**Project Name: CR-880 and Sam Senter Road over the South Florida Water
Management District (SFWMD) Ocean Canal Intersection Improvements and
Bridge Replacement.**

Project Number: 2019803

Addendum No. 4

Date of Issuance: October 9, 2026

PALM BEACH COUNTY
ENGINEERING AND PUBLIC WORKS
ROADWAY PRODUCTION
P.O. BOX 21229, WEST PALM BEACH, FLORIDA

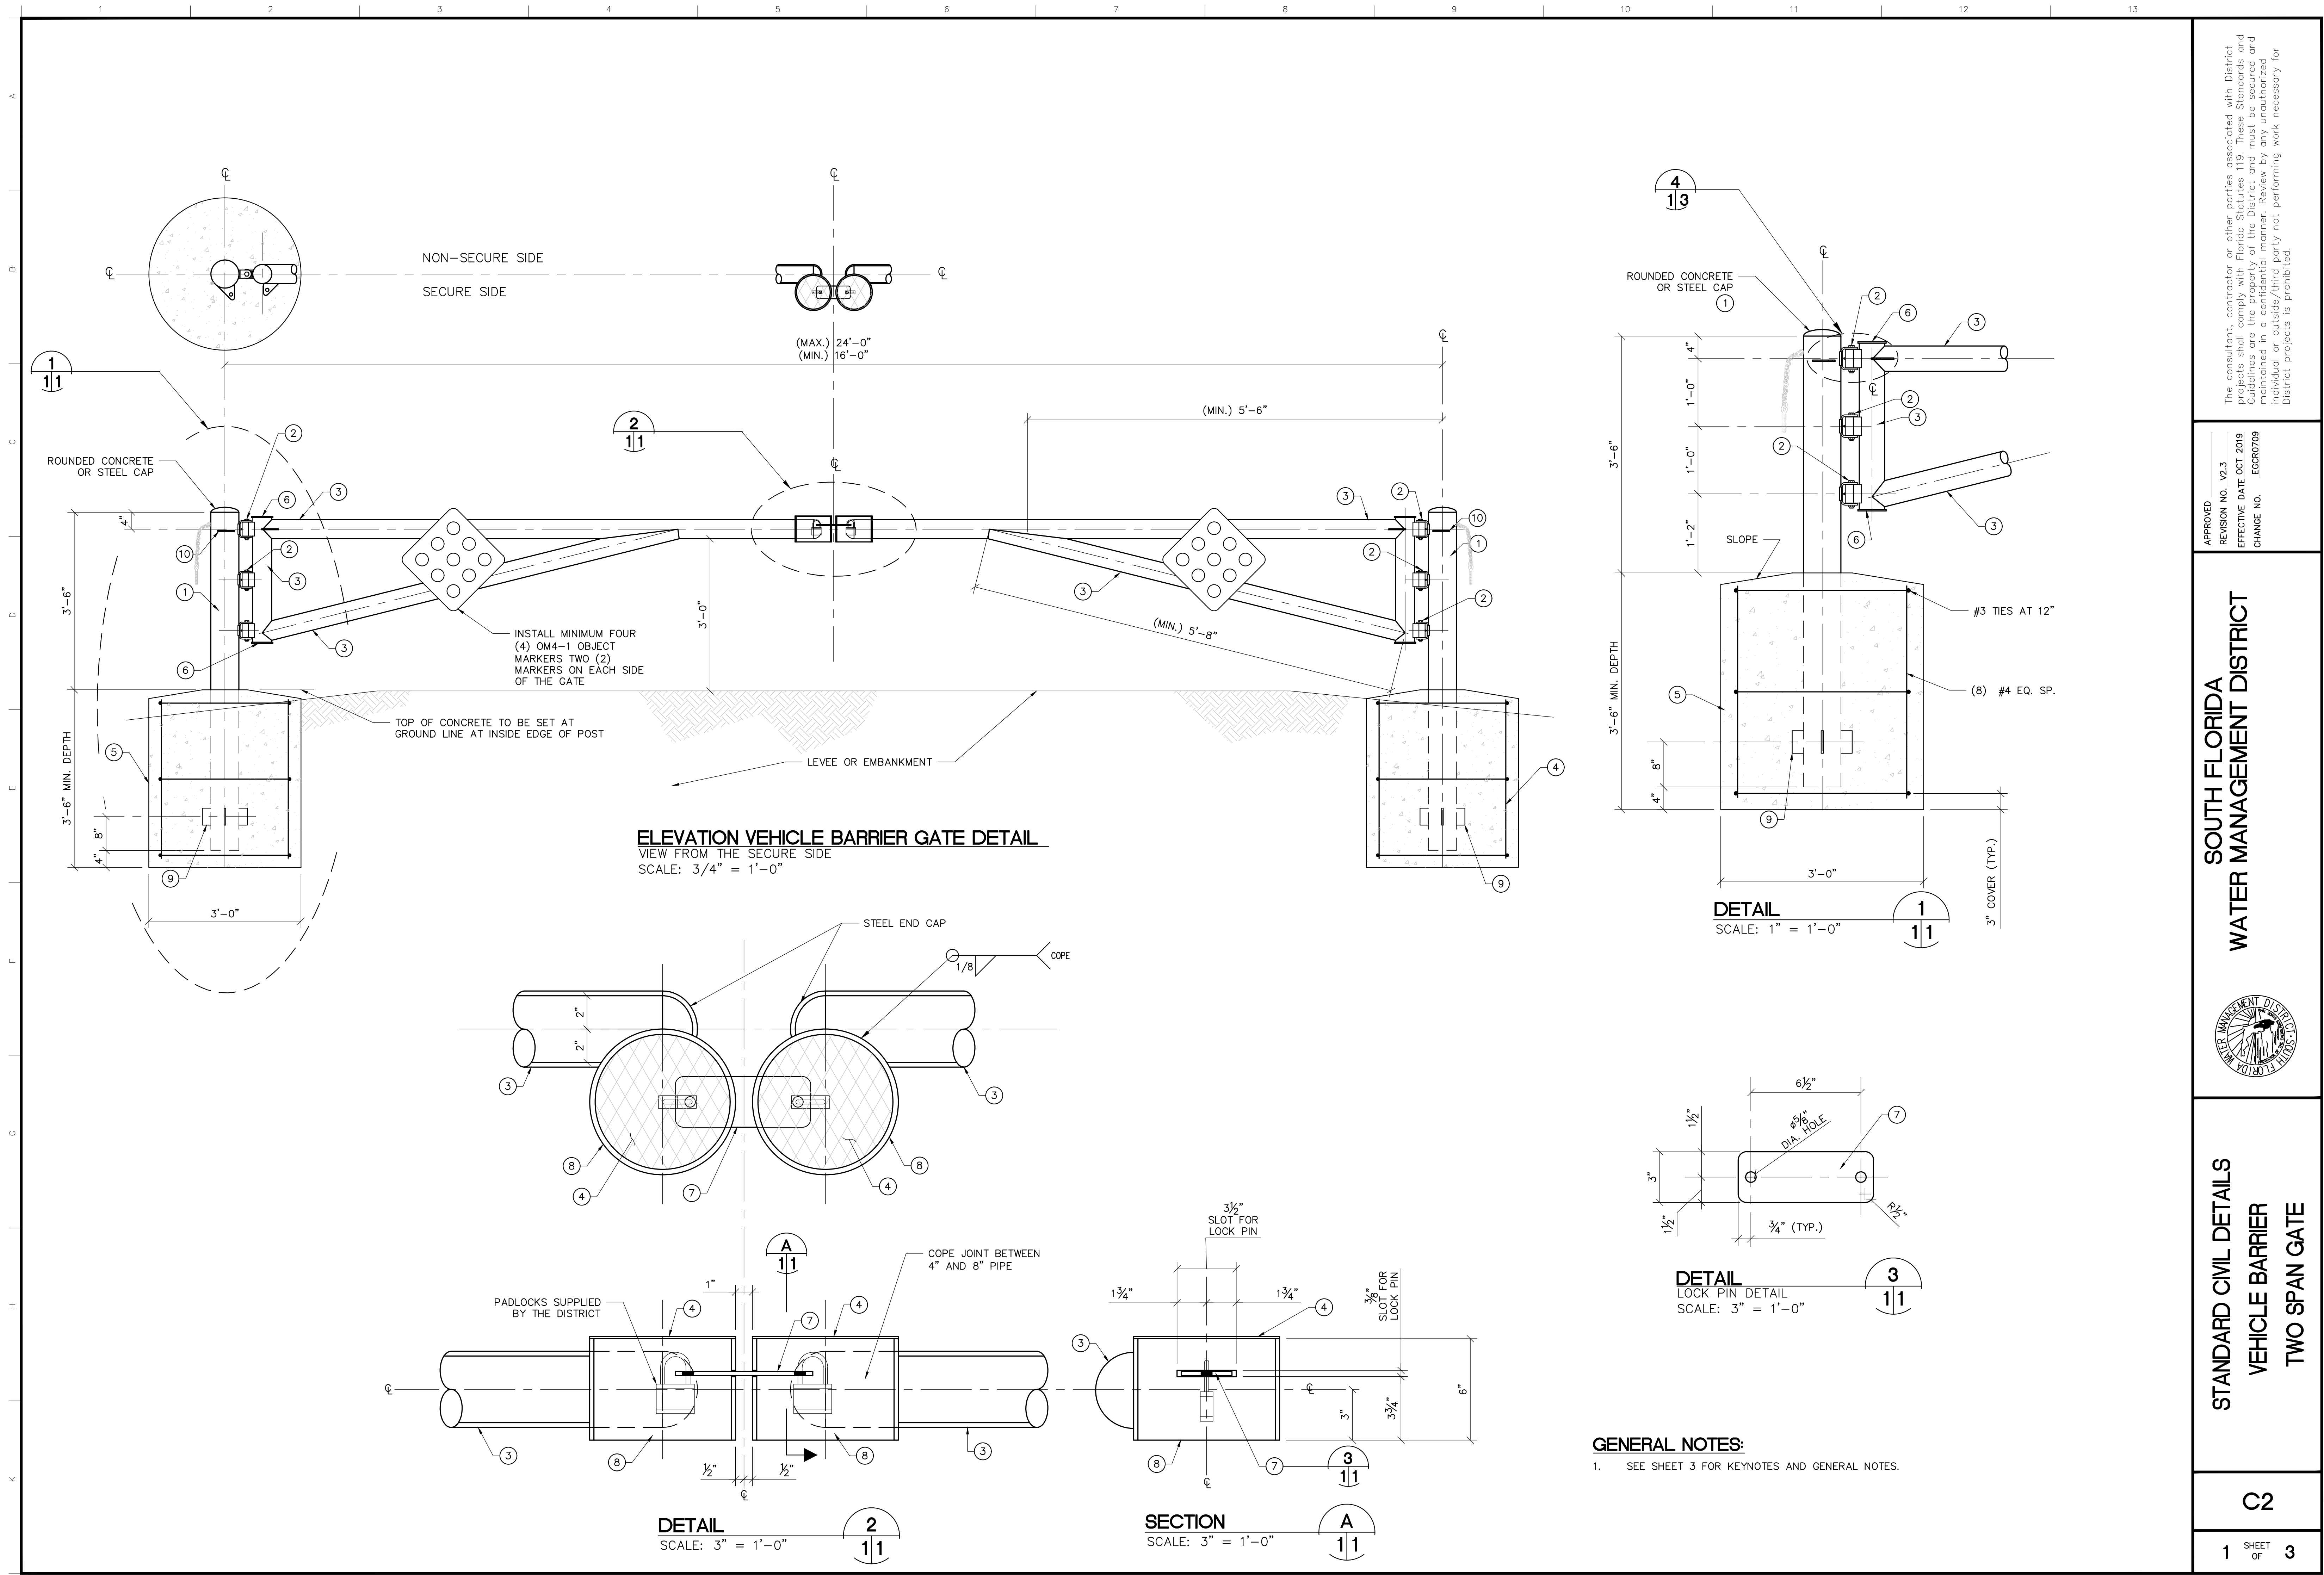
QUESTION: Could you provide the Soil Survey sheets in the roadway plans? They are mentioned in the table of contents, but the sheets are missing in the plans.

QUESTION: It appears plan sheets C2 1 of 3, C2 3 of 3, and GR-1 thru GR-6 are missing from the bid documents. They are listed on the cover sheet. Can they please be provided?

QUESTION: Please provide the Roadway Soil Survey sheets GR-1 thru GR-6.

RESPONSE: Sheets GR1 – GR6 have been provided in this addendum.

RESPONSE: Sheets C2 1 of 3, C2 3 of 3 and GR1 – GR6 have been provided in the addendum.

RESPONSE: Provided in this Addendum

TYPICAL VEHICLE BARRIER GATE INSTALLATION
TWO SPAN GATE
NOT TO SCALE

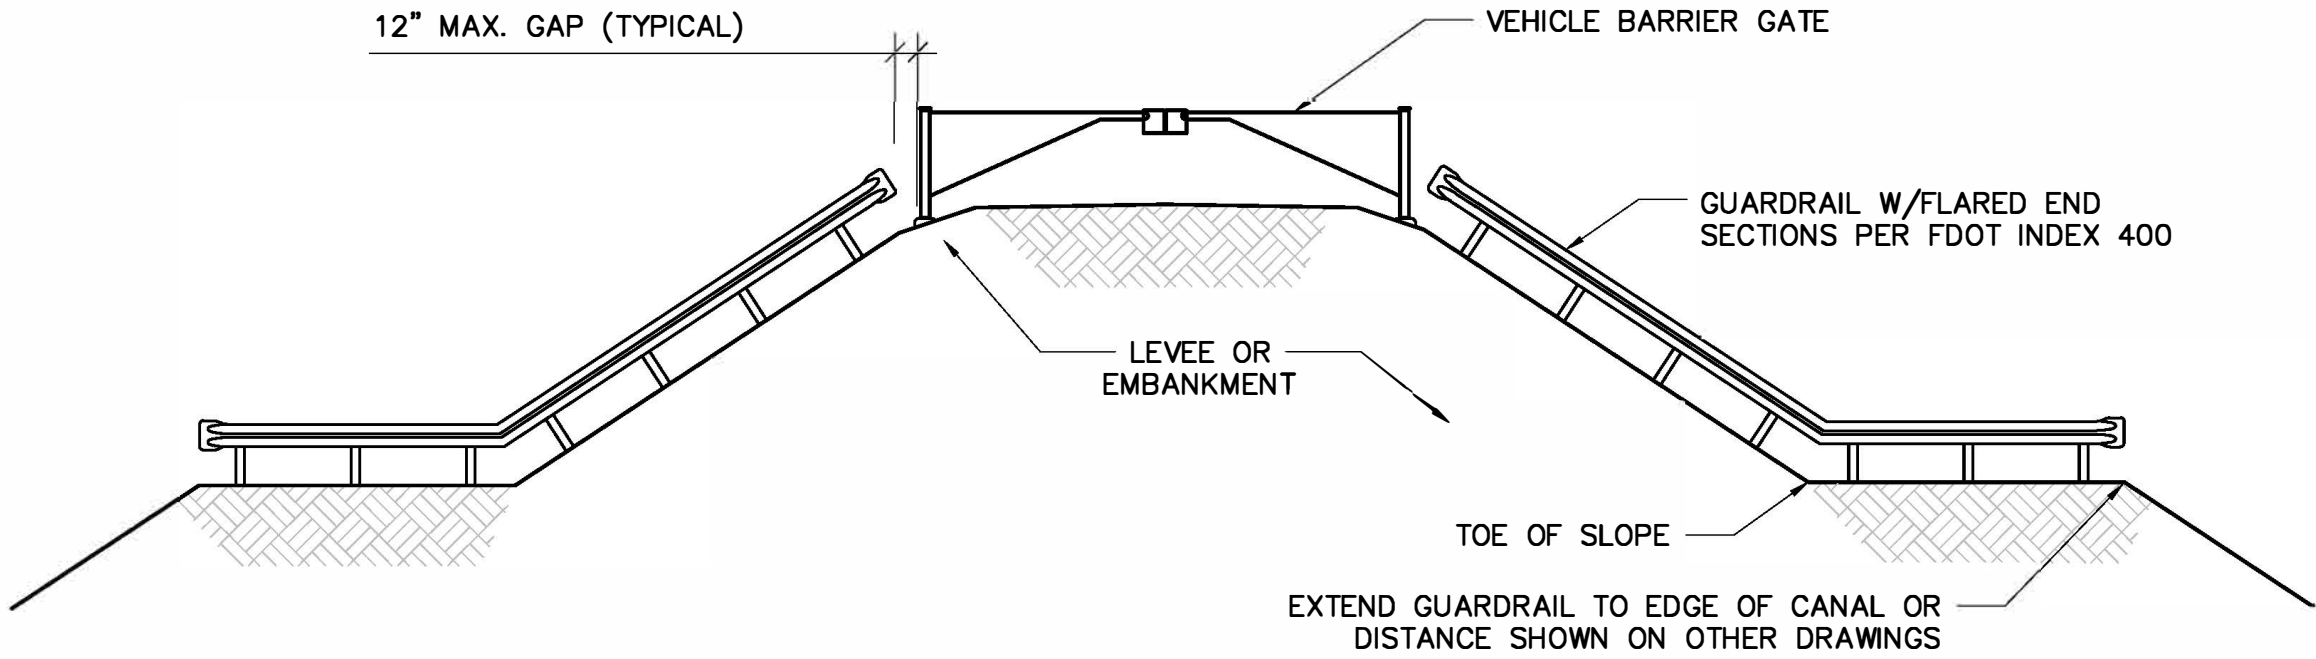
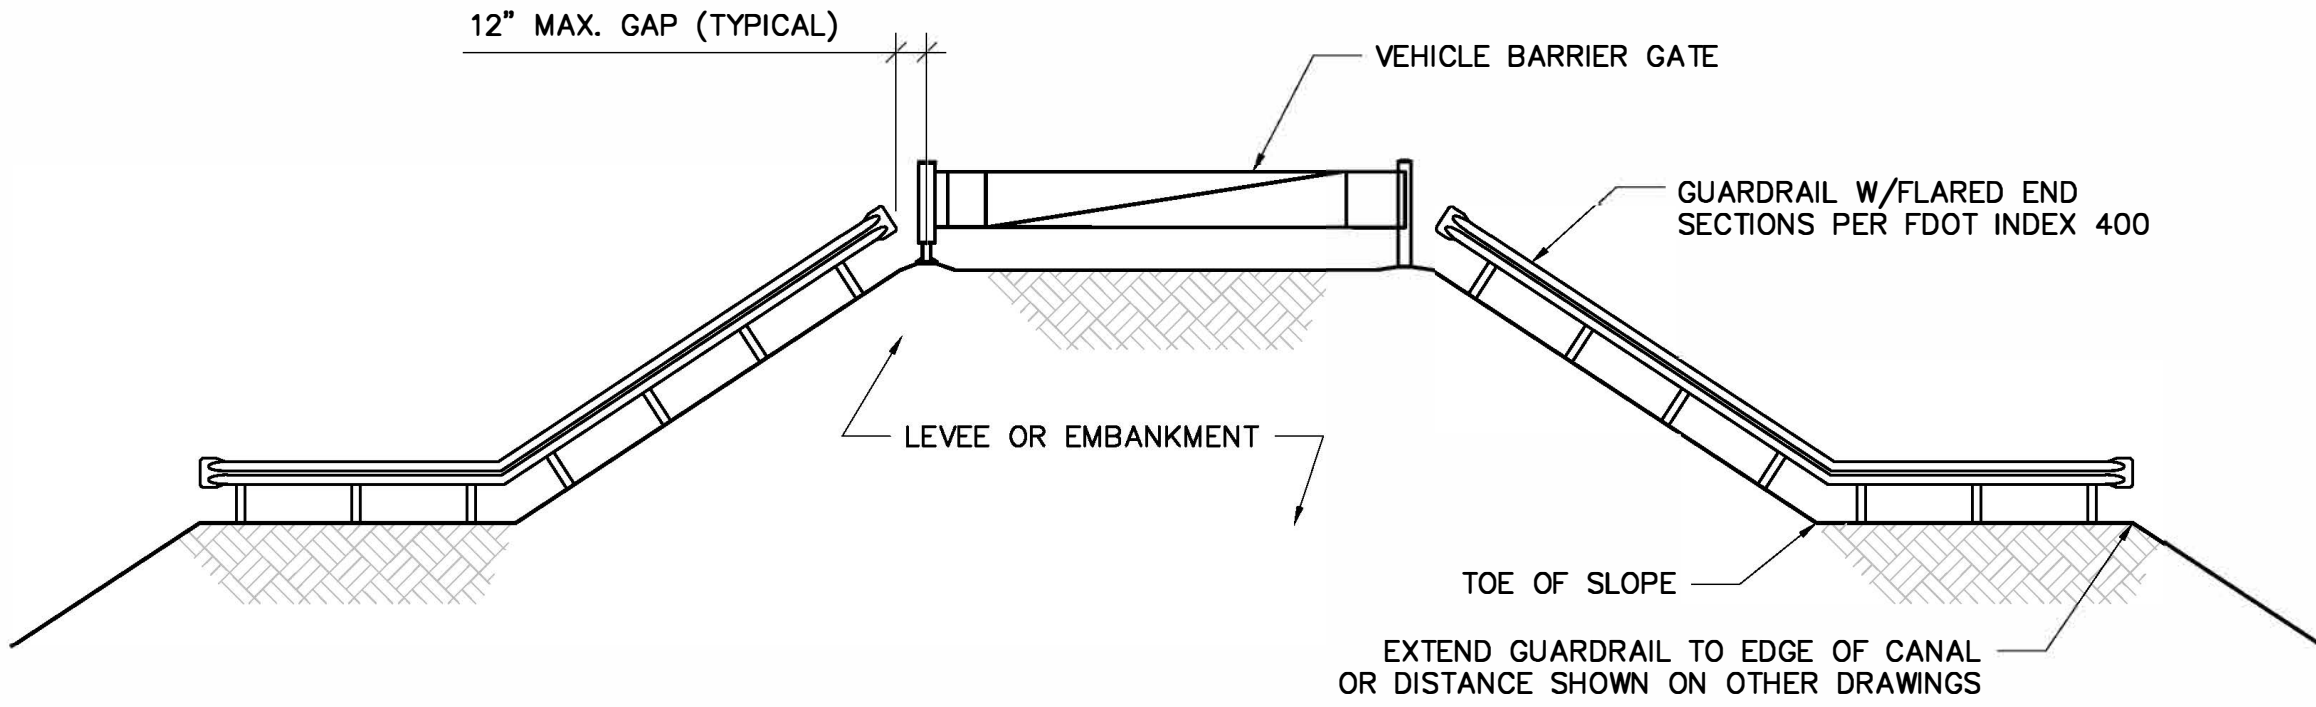
QUESTION: . Plan Sheet 36. The note for the SFWMD gate says to refer to the SFWMD gate details. I don't see the detail in the plans. Can the detail be provided?

QUESTION: Sheet 36 of Roadway Plans part 2 of 3 references – “See SFWMD Gate Details”

QUESTION: We cannot find the C2 sheets – “SFWMD Standard Civil Details Vehicle Barrier Two Span Gate”.

RESPONSE: Refer to SFWMD Permit for gate detail, Sheets 1 and 3.

RESPONSE: Gate details provided in this addendum.

RESPONSE: Gate details provided in this addendum.
